THE BAILEY
SECOND FLOOR PLAN WITH
BONUS ROOM OPTION

PLAN NO. 2424

PLAN NAME:
THE BAILEY

SHEET TITLE:
STRUCTURAL OPTIONS

3 FIRE PLACE OPTION
1/4" = 1'-0"

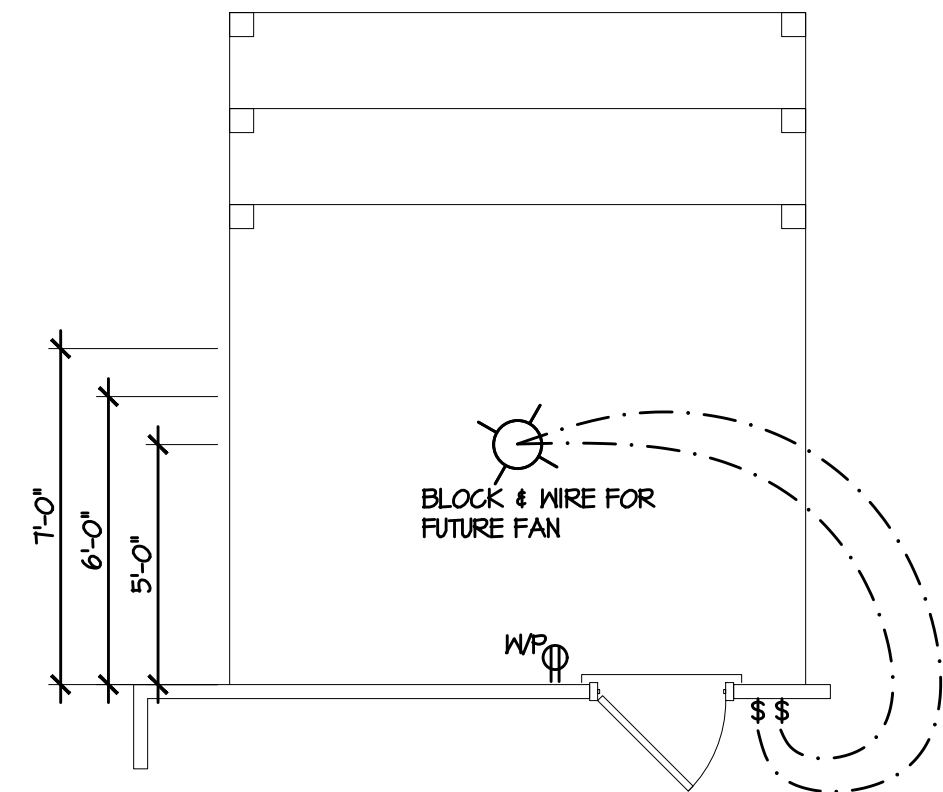
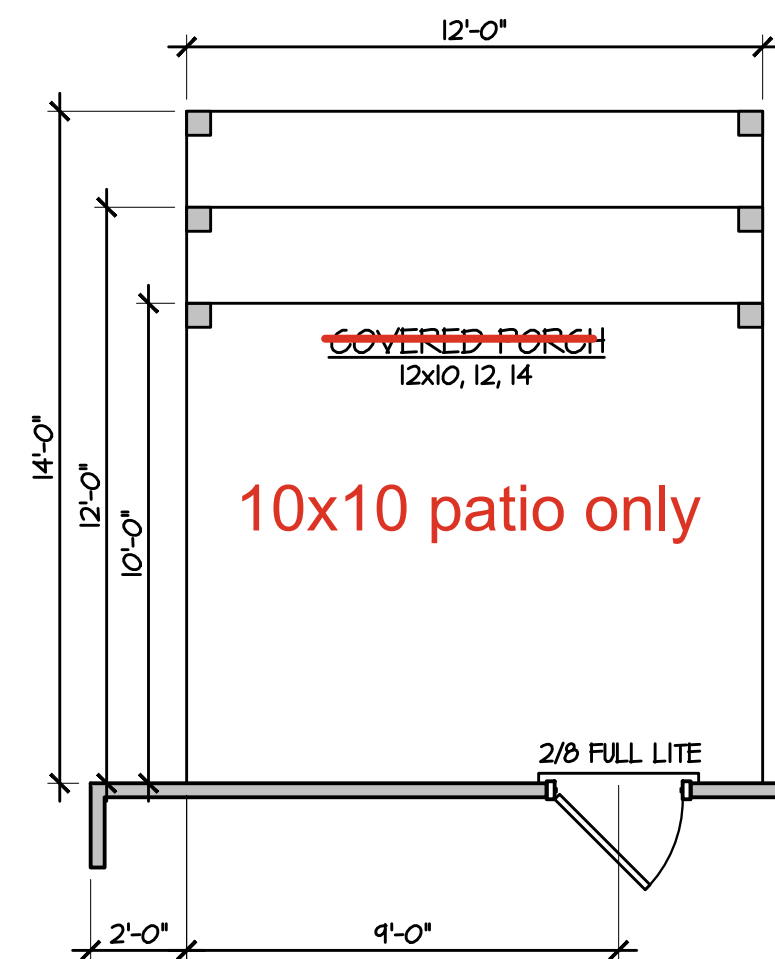
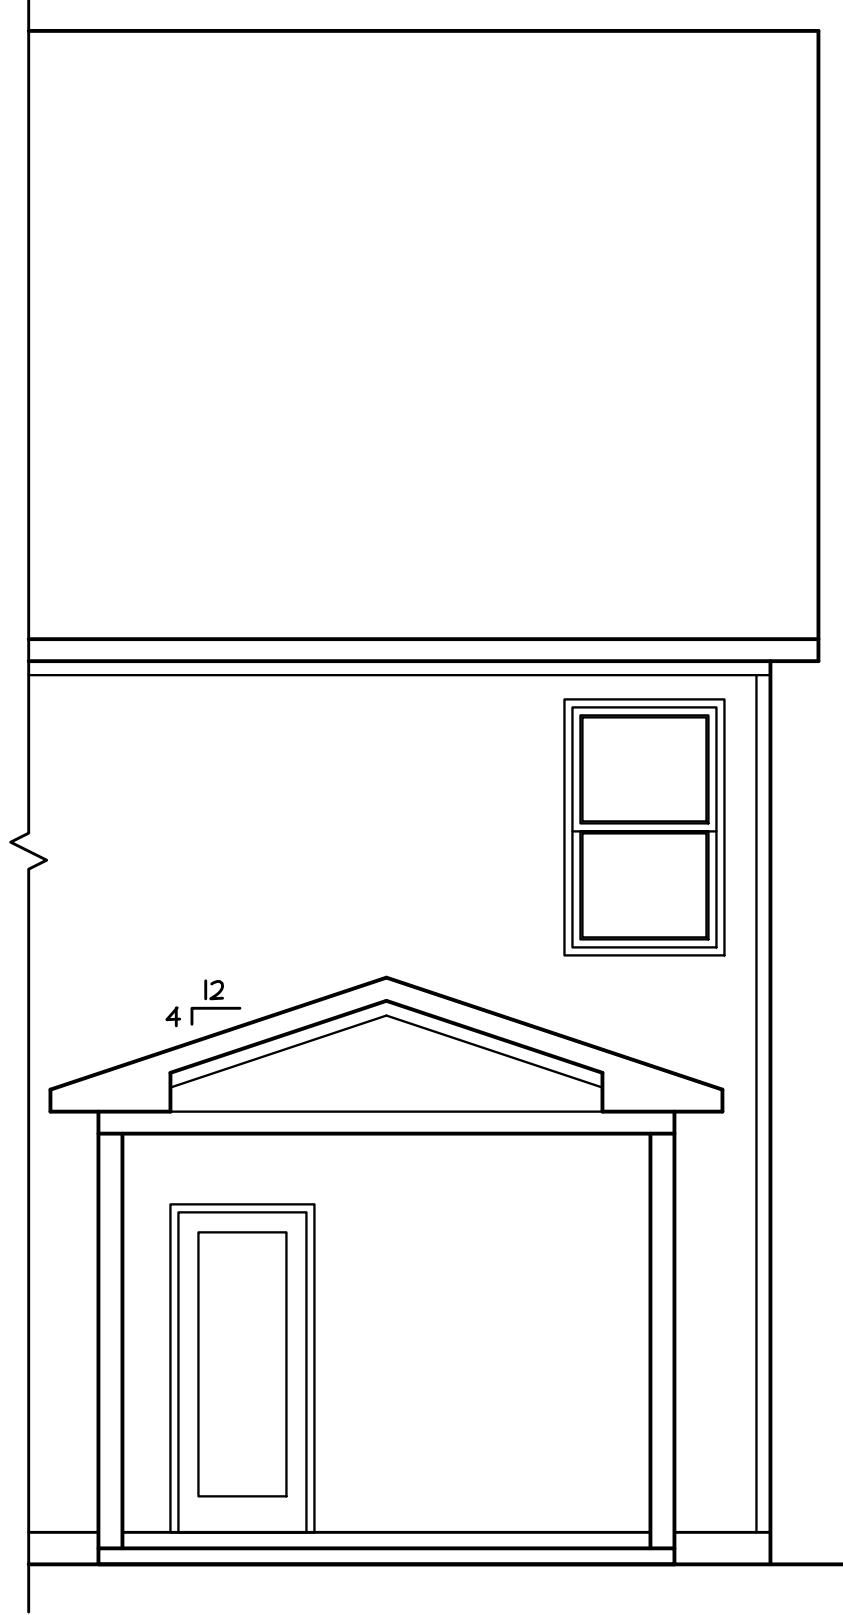
YES

2 ~~REAR PORCH OPTIONS~~
1/4" = 1'-0"

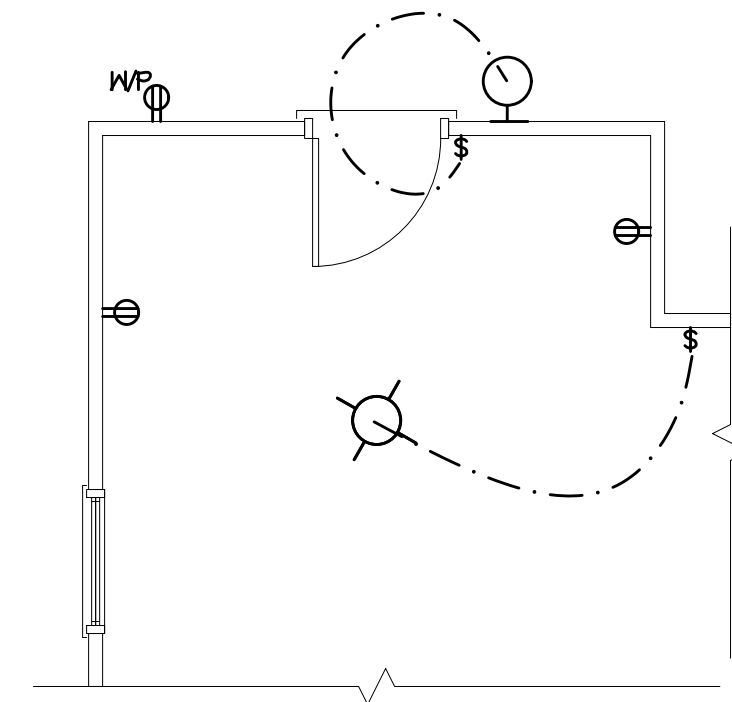
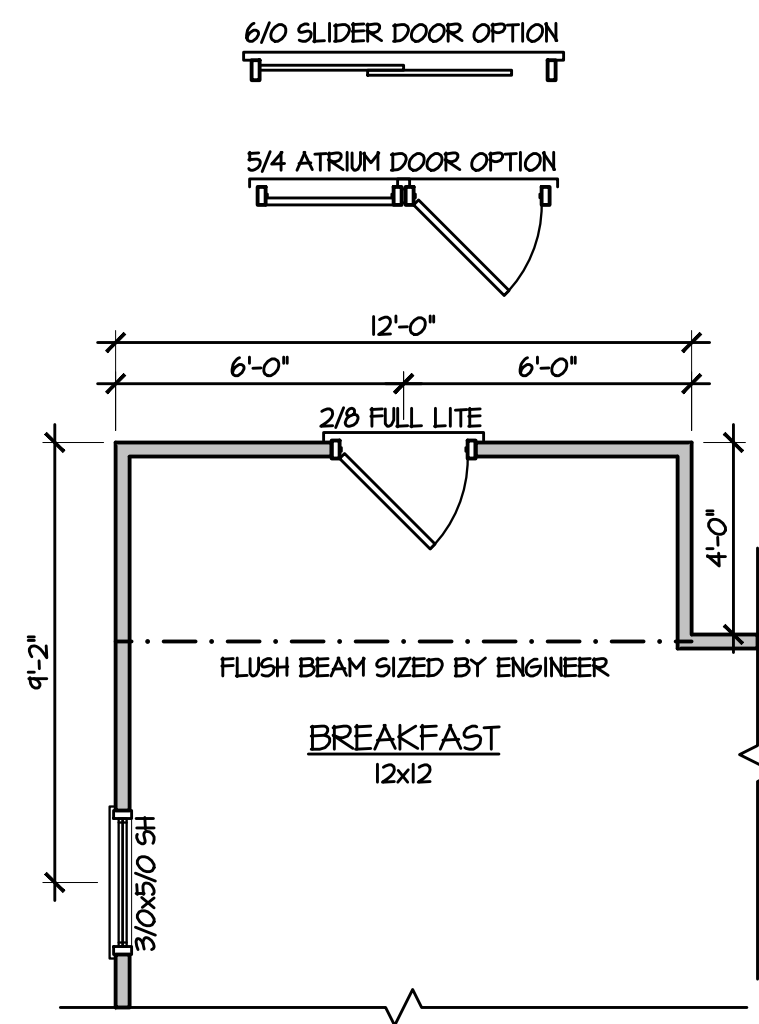
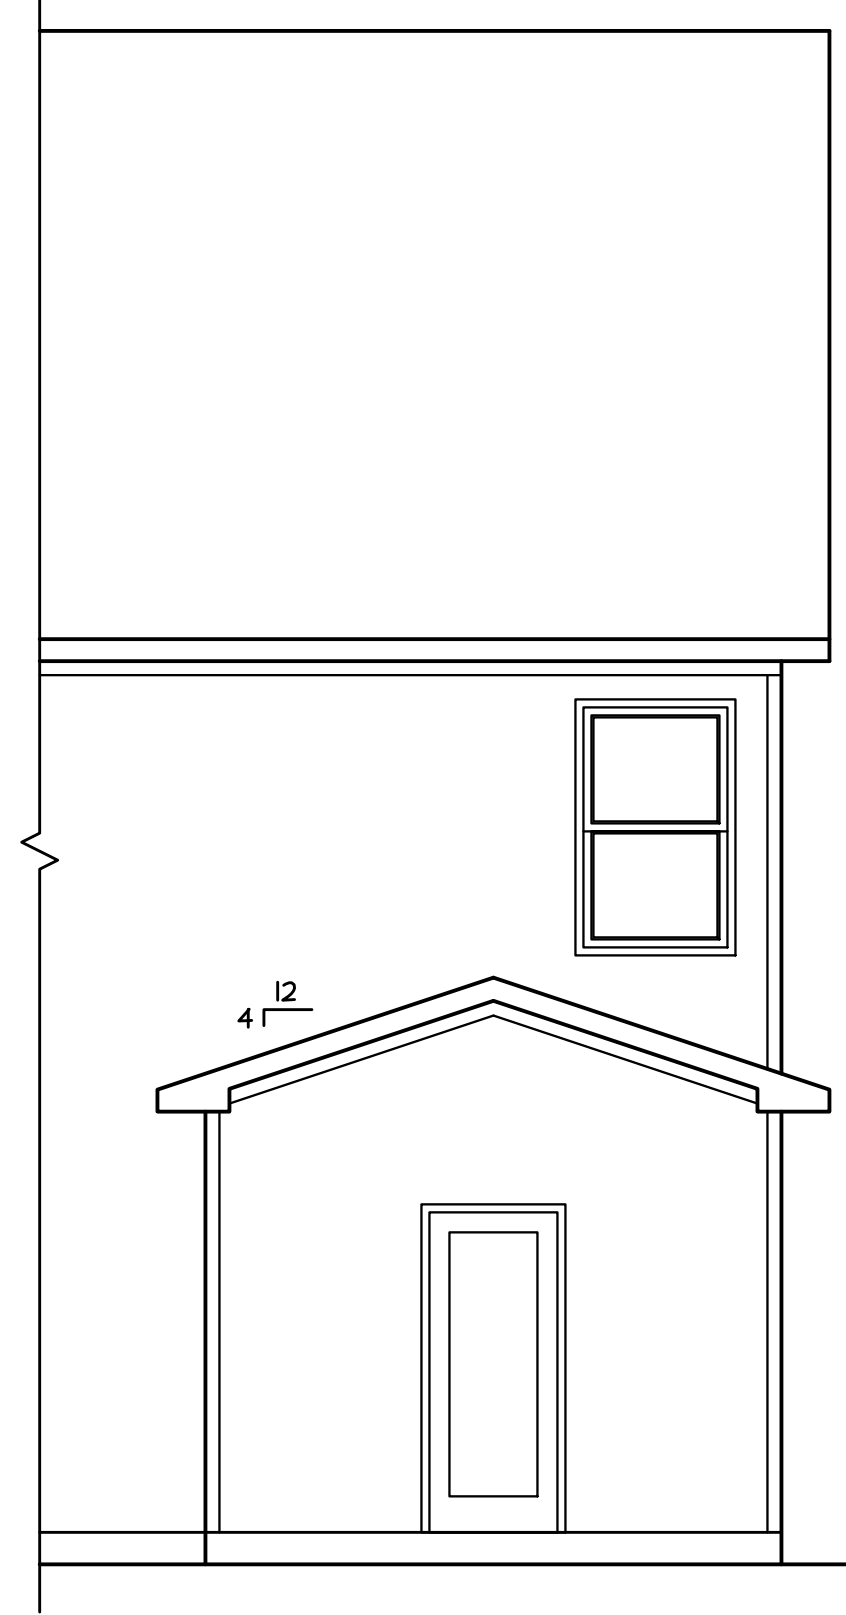
10x10 patio only
